R. M. WESTER *and ASSOCIATES, INC.*
215 INDACOM DRIVE - ST. PETERS, MISSOURI 63376
(636) 928-9628 - FAX (636) 928-9857

January 13, 2006

RE: TELCON, Environmental Safety SLU, Jan 06 06 07:08p

Thank you for your questions and comments regarding the Saint Louis University Decommissioning Survey Report, dated October 27, 2005. I hope the above information answers your questions.

Figure C22: Clean Storage Floor Grid and Layout

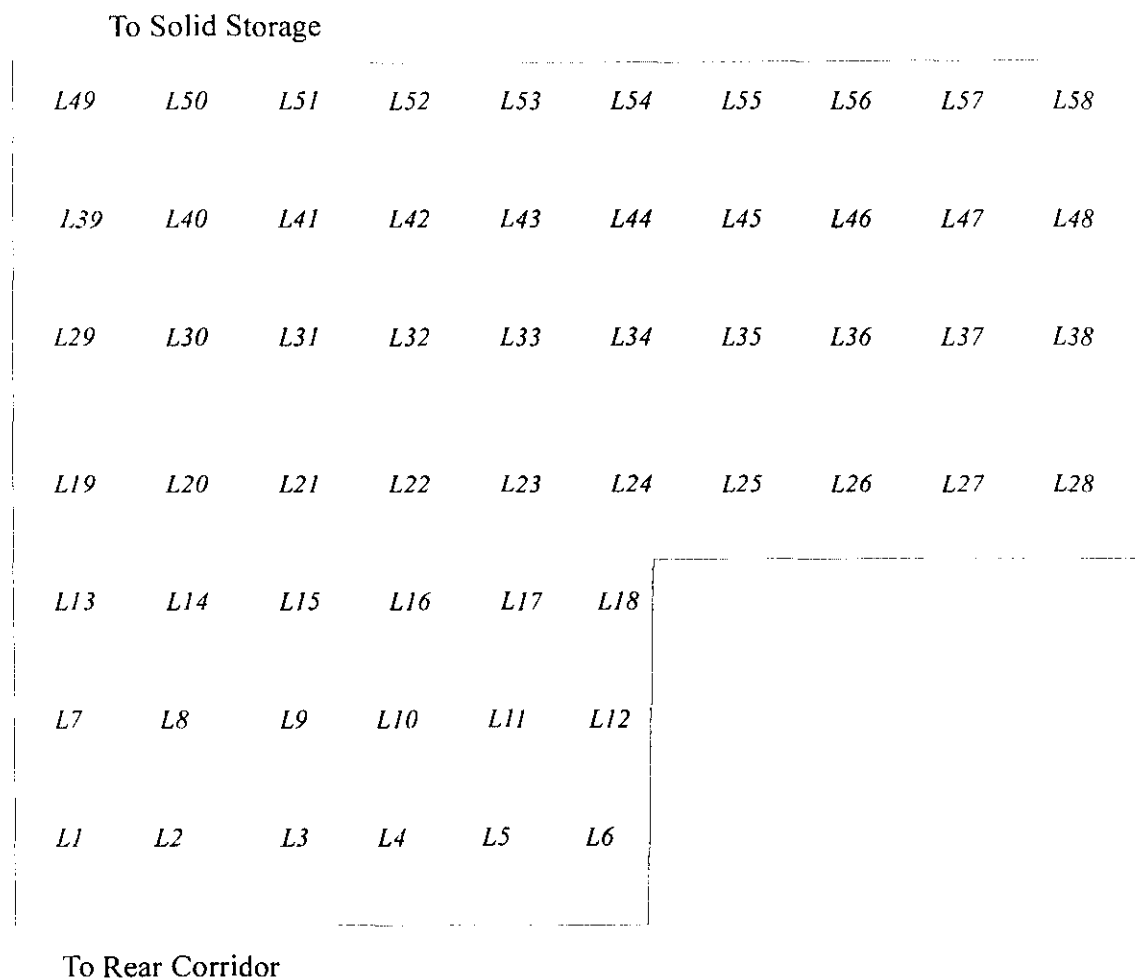
d. Page 24 refers to the Clean Storage area.
